TRANS/WP.29/2003/84  
30 July 2003

World Forum for Harmonization of Vehicle Regulations (WP.29)

PROPOSAL FOR DRAFT SUPPLEMENT 6 TO THE 03 SERIES OF AMENDMENTS TO  
REGULATION No. 44

(Child restraints)

Figure 1

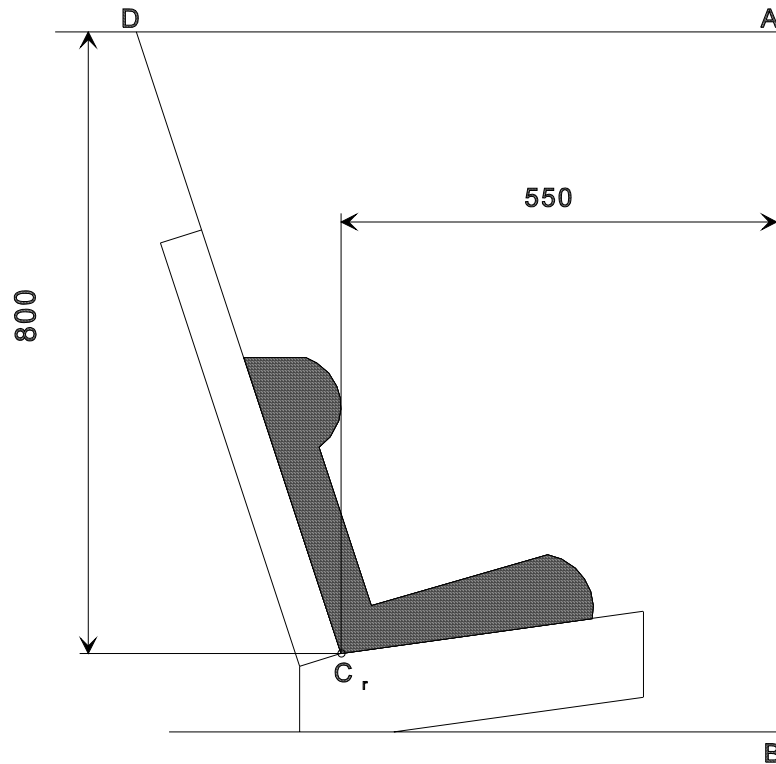
Paragraph 7.1.4.4.1.1., amend to read:

"7.1.4.4.1.1. Forward facing child restraints: the head of the manikin shall not pass beyond the planes BA and DA as defined in Figure 1 below. This shall be judged up to 300 ms or the moment that the manikin has come to a definitive standstill whatever occurs first.

**Figure 2:**  
**Arrangement for testing**  
**a rearward-facing device**

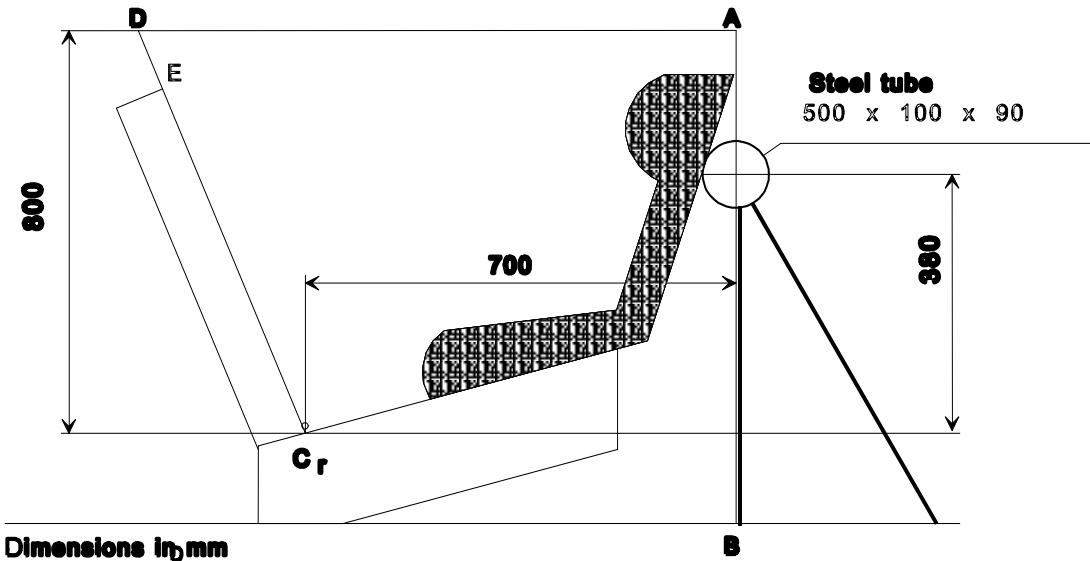
Paragraph 7.1.4.4.1.2.1., amend to read:

"7.1.4.4.1.2.1. Child restraints supported by dashboard: the head of the manikin shall not pass beyond the planes AB, AD and DCr, as defined in Figure 2 below. This shall be judged up to 300 ms or the moment that the manikin has come to a definitive standstill whatever occurs first.

Figure 3

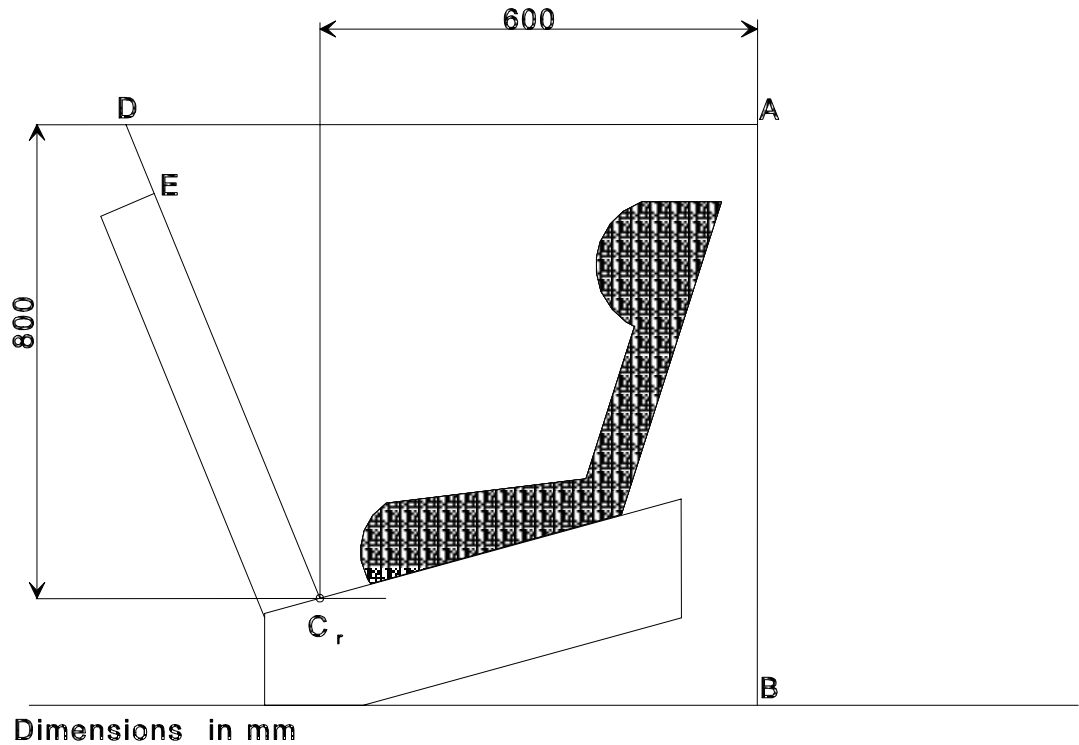
Paragraph 7.1.4.4.1.2.2., amend to read:

"7.1.4.4.1.2.2. Child restraints in group 0 not supported by the dashboard, and carrycots: the head of the manikin shall not pass the planes AB, AD and DE as shown in Figure 3 below. This shall be judged up to 300 ms or the moment that the manikin has come to a definitive standstill whatever occurs first.

Figure 1: Standard seat belt configurations"

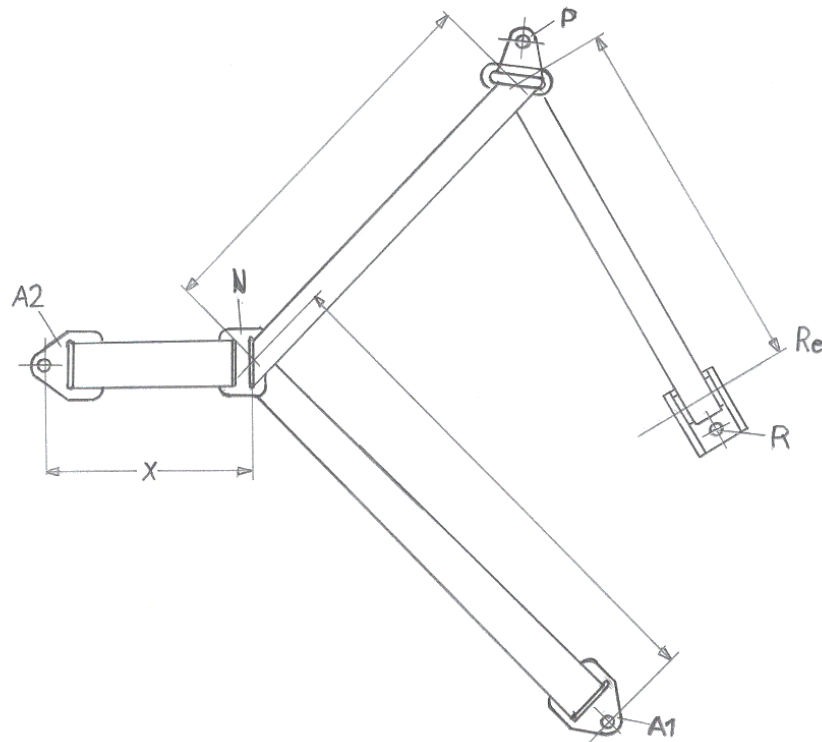
Belt retractor R shall be fitted to trolley anchorage such that the spool centre-line is positioned on Re.

The value of X in Figure 1 below is  $200 \pm 5$  mm. The effective strap length between A1 and the centre-line of the retractor spool Re (when the webbing is fully extracted including the minimum length of 150 mm \*/ for testing of universal and semi-universal categories shall be  $2820 \pm 5$  mm when measured in a straight line without load and on a horizontal surface; this length may be increased for testing of restricted category; for all categories with the child restraint installed there shall be a minimum of 150 mm \*/ of strap length on the retractor spool."

Figure 1, amend to read:
